APPLICATION NO.	FILING DATE	FIRST NAMED INVENTOR	ATTORNEY DOCKET NO.	CONFIRMATION NO.
10/711,144	08/27/2004	Douglas D. Coolbaugh	BUR920040107US1	5143

Office Action Summary	Application No. 10/711,144	Applicant(s) COOLBAUGH DOUGLAS D. ET AL.	
	Examiner Khiem D. Nguyen	Art Unit 2823

DETAILED ACTION

Fig. 11

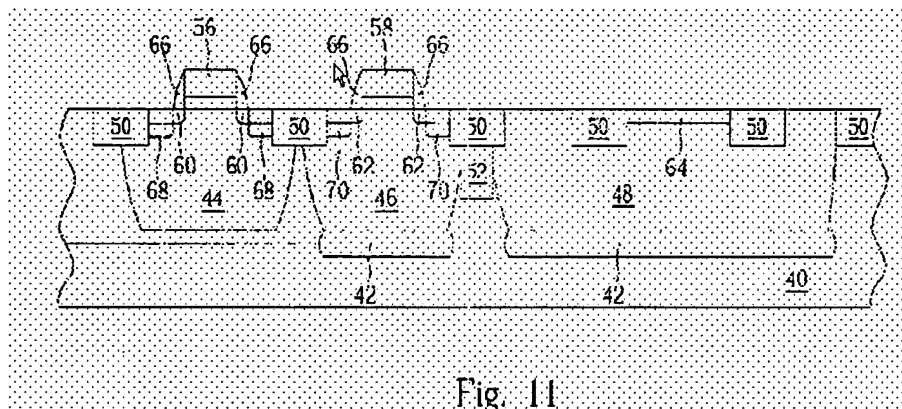
In re claim 1, Gau discloses a varactor structure comprising: a semiconductor substrate 40 of a first conductivity type, the substrate 40 including a subcollector 42 of a second conductivity type (col. 4, lines 11-30) located below an upper region of the substrate 40, the first conductivity type is different from the second conductivity type; a

well region located in the upper region of the substrate 40, wherein the well region includes outer well regions 44/48 of the second conductivity type and an inner well region 46 of the first conductivity type, each well of the well region is separated at an upper surface by an isolation region 50 (col. 4, lines 31-40 and FIG. 11) and

each outer well region has an upper surface which includes a source/drain region 60/62 (col. 4, lines 57-67); and a field effect transistor having at least a gate conductor 58 of the first conductivity type located above the inner well region 46 (col. 4, line 67 to col. 5, line 6 and FIG. 11).

In re claim 5, as applied to claim 1 above, Gau discloses all claimed limitations including the limitation wherein each well region extends beneath the isolation region 50 such that neighboring well regions are in contact with each other (FIG. 11).

In re claim 7, as applied to claim 1 above, Gau discloses all claimed limitations including the limitation wherein the field effect transistor further comprises a gate dielectric located beneath the gate conductor 58, a hard mask located on the gate conductor, at least one spacer 66 located on sidewalls of the gate conductor 58 and abutting source/drain regions 62 (col. 4, line 67 to col. 5, line 5 and FIG. 11).

In re claim 9, Gau discloses a varactor structure comprising a p-type semiconductor substrate 40, the p-type substrate including an n-type subcollector 42 located below an upper region (col. 4, lines 11-30) of the substrate 40; a well region located in the upper region of the substrate 40, wherein the well region includes outer N-well regions 44/48 and an inner P-well region 46, each well of the well region is separated at an upper surface by an isolation region 50 (col. 4, lines 31-40 and FIG. 11) and

each outer well region has an upper surface which includes a source/drain region 60/62 (col. 4, lines 57-67) and a field effect transistor having at least a p-type gate conductor 58 located above the inner P-well region (col. 4, line 67 to col. 5, line 6 and FIG. 11).

In re claim 11, as applied to claim 9 above, Gau discloses all claimed limitations including the limitation wherein each well region extends beneath the isolation region 50 such that neighboring well regions are in contact with each other (FIG. 11).

In re claim 13, as applied to claim 9 above, Gau discloses all claimed limitations including the limitation wherein field effect transistor further comprises a gate dielectric located beneath the gate conductor 58, a hard mask located on the gate conductor 58, at least one spacer 66 located on sidewalls of the gate conductor 58 and abutting source/drain regions 62 (col. 4, line 67 to col. 5, line 5 and FIG. 11).
